MO/2016/1848

Planning & Regulatory Committee 22 February 2017

UPDATE SHEET**MINERALS/WASTE MO/2016/1848****DISTRICT(S)** MOLE VALLEY DISTRICT COUNCIL**Land at Bury Hill Wood, off Coldharbour Lane, Holmwood, Surrey RH5 6HN****Details of a pre and post development condition survey (method statement) pursuant to Condition 20 (ii) of appeal ref: APP/B3600/A/11/2166561 dated 15 August 2015.****CONSULTATIONS AND PUBLICITY*****Additional key issues raised by public***

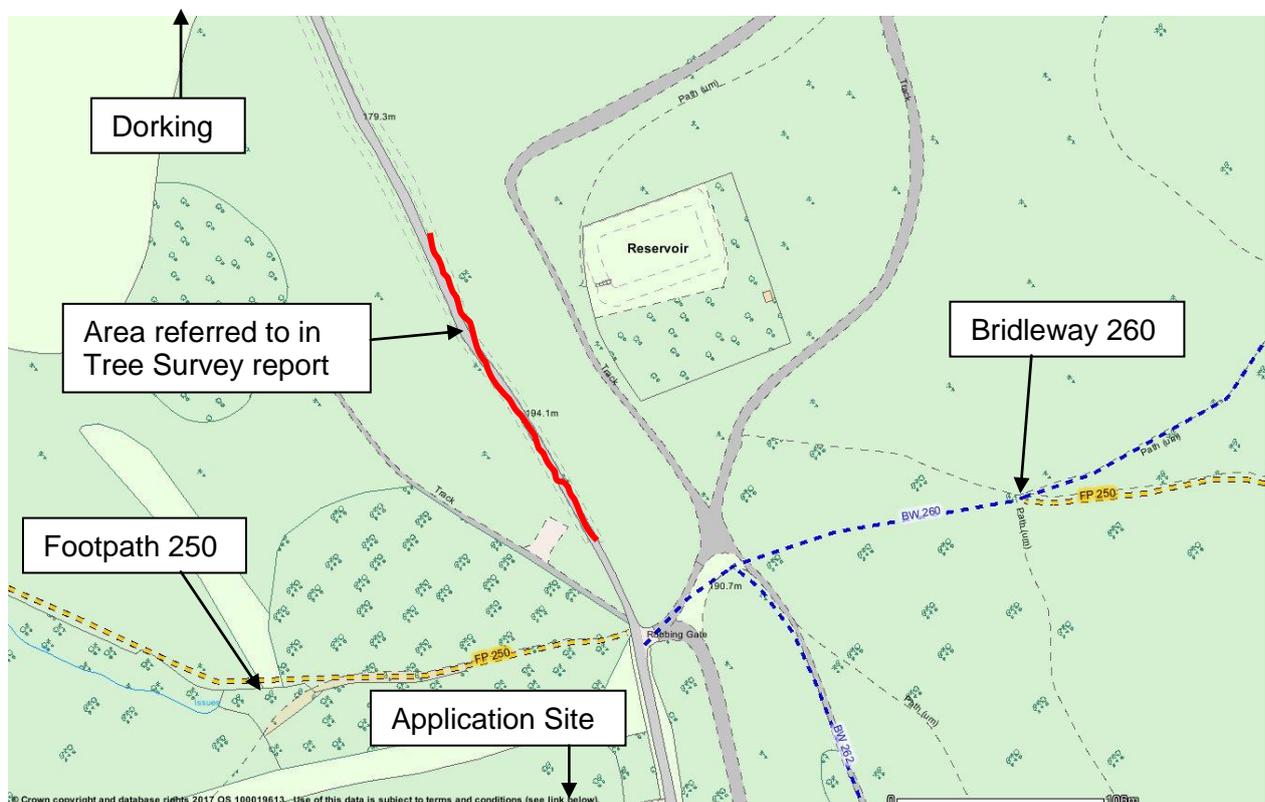
A Tree Survey has also been submitted to accompany two letters of representation. This tree survey has been provided identifying vulnerable trees along the narrowest stretch of Coldharbour Lane on the stretch known as Boar Hill approximately 175m in length commencing some 55m north of Robbing Gate (where footpath 250 joins Bridleway 260) as can be seen below:

The applicant has confirmed that the whole traffic management scheme is geared to avoidance of damage to the trees. Given that most of the trees are rooted at a height well above the carriageway the potential for damage to the roots is much reduced. In the unlikely event that damage is caused by the vehicles serving the development, the applicant would apply best practice (that encompasses BS 3998) in taking appropriate action and a trained arboriculturalist would be employed.
